12 April 2019

**Re: SSD 7172 Hume Coal Project & SSD 7171 Berrima Rail Project –  
Response to submission by Mr Derek White**

**Figure 2.1** Example of AHTM Drill Rig (Palaris 2019)

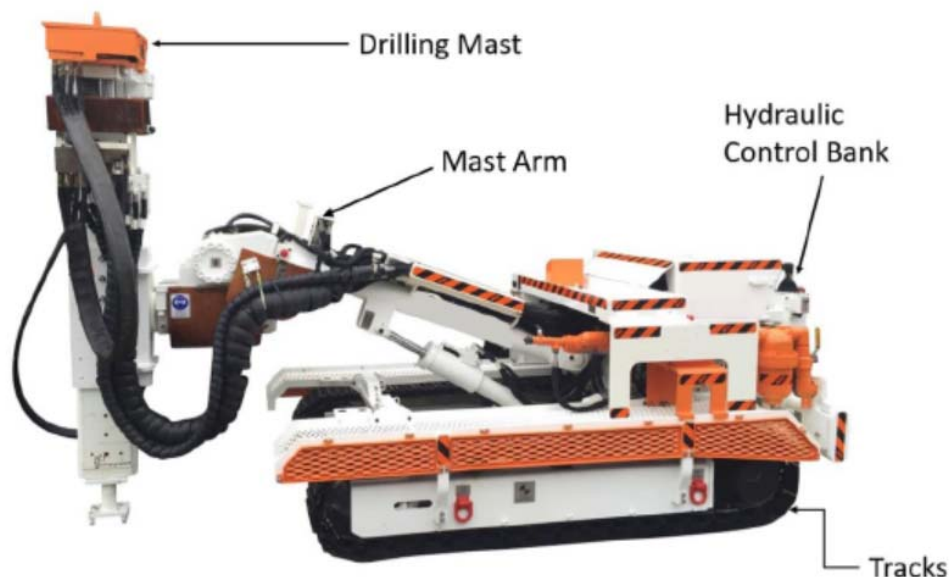
*Mr White raised concerns that the pumping rejects material poses significant engineering and safety challenges associated with the emplacement of reject within the headings. This included potential for the placement of rejects to require the use of a bulldozer to ensure panels are adequately filled.*

Hume Coal plan to utilise a modified air/hydraulic track mounted (AHTM) drill rig to carry out the process of reject emplacement (refer to Figure 2.1). An AHTM drill rig is a piece of machinery commonly used underground for the installation of rock bolts in the underground roadways. These machines comprise a track mounted drilling mast where all motors are driven by compressed air (rotational motor, feed motor and tram motor). The rotational and feed motors are used for drilling and installing the rock bolts whilst the tram motor drives the tracks which are used for manoeuvring the machine.

Hume Coal will collaborate with the equipment manufacturer (OEM) to modify the AHTM rig in order to remove the drilling mast and replace it with a discharge nozzle that will mount onto the mast arm. This nozzle will be used as a discharge point to distribute and emplace the reject material. A discharge line of 90 mm internal diameter transporting the reject material would then be connected to the nozzle as a means of feeding the reject to the discharge point.

Additionally, Hume Coal will collaborate with the equipment manufacturer (OEM) to remove the hydraulic control bank that operates the tracks and mast from the body of the machine by the use of umbilical hydraulic lines extending from the rig to the entrance of each plunge. By doing this, the equipment operator will be able to activate all functions of the rig remotely.

A further requirement to be addressed will be the ability to recover the rig remotely in the event of an equipment malfunction when pumping in the plunges. As plunges are unsupported, a remote recovery device is mandatory to avoid personnel having to enter unsupported roof areas. This will be achieved by the use of a recovery strap attached to the AHTM rig and deployed as the AHTM rig enters each plunge. In the event of a breakdown, the strap can be attached to an underground tractor type machine (LHD) and recovered from the plunge so it can be repaired.

**Figure 2.2 Theoretical porosities in and along the goaf (AECOM 2018)**

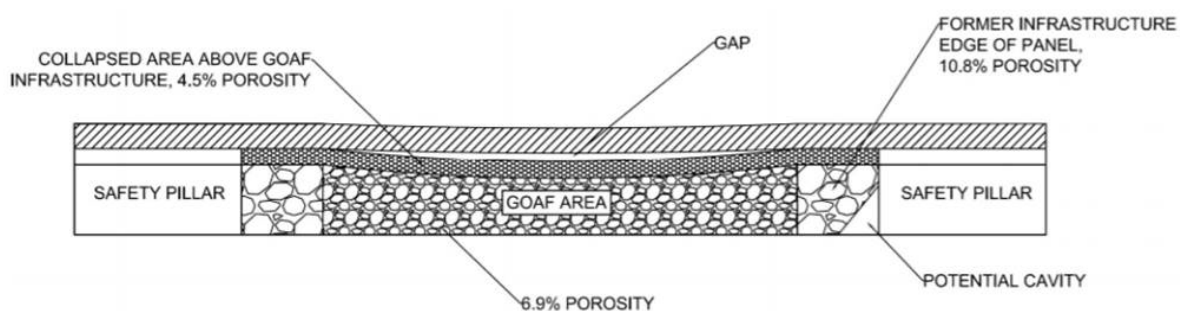
*Mr White provided commentary on a study conducted for the Tahmoor Coking Coal Project (Tahmoor), which evaluated options for disposal of coal reject material. Mr White drew comparison between the Hume Coal Project and Tahmoor. Specifically, Mr White highlighted that the Tahmoor study concluded that placement of 100% of rejects underground was not feasible due to physical constraints and the lack of availability of fill preparation plants.*

Backfill disposal at Tahmoor Coal was considered in an options study (Appendix U of the Tahmoor South Coal EIS (AECOM 2018) “Rejects Disposal Study Report”).

For underground coal rejects emplacement, the use of additives was envisaged to improve the slurry rheology. No details were provided within the report on the modifier selected. The backfill produced had to be able to permeate through collapsed goaf and be resistant to re-fluidization. Both the options of pumping low density (30-50% solids w/w) and high-density slurry (75-85% solids w/w) were investigated. The addition of a paste thickening plant was required to thicken the tailings for the high-density pumping option.

It also needs to be noted that the situation at Tahmoor Mine is different to Hume, in that Tahmoor is an operating, longwall mining operation. The mine has been operating for 40 years and was constructed without the infrastructure to enable underground emplacement. Further, there is limited void space available for underground emplacement in a longwall mine due to the caving in of overburden material following coal extraction (ie the goaf), as illustrated in Figure 2.2. This is different, and more challenging than Hume Coal’s proposal, where roadways will remain intact and be able to accept the emplacement methodology.

**Figure 2.3** Indicative rejects emplacement schedule

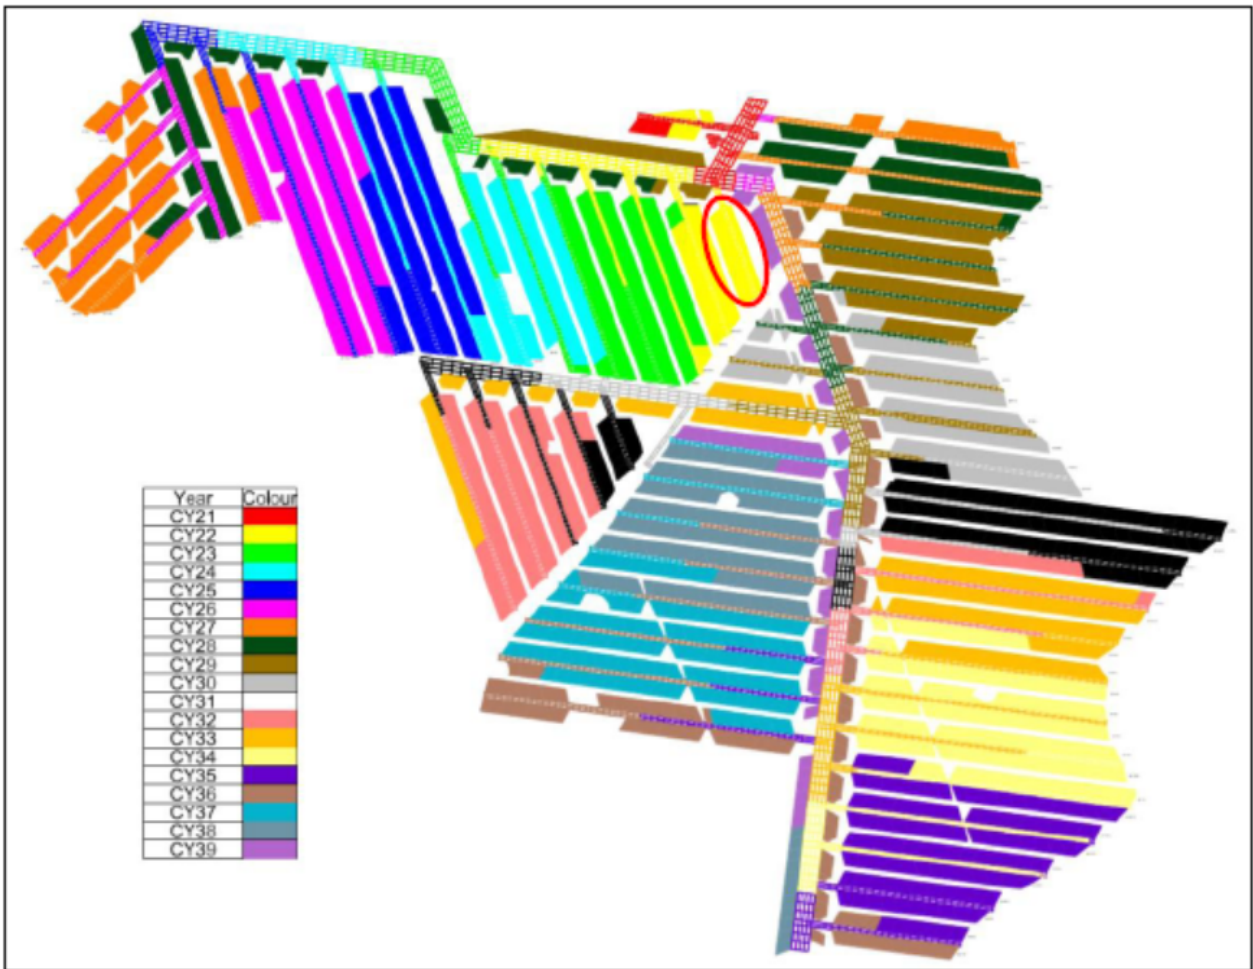
*Mr White states that the management of rejects underground has not been adequately addressed in the EIS.*

As stated in the EIS (EMM 2017), rejects initially generated by the project from the first panel in the western area of the mine will be stored on the surface in the temporary surface reject stockpile. This will equate to approximately 500,000 tonnes of rejects. This reject will be scheduled for eventual underground delivery during the life of the project.

The indicative schedule of reject emplacement is shown in Figure 2.3. The first panel to be emplaced is circled in red.

This schedule was developed by Palaris using the Deswick mine planning software, which is a well-known mining simulation software package.
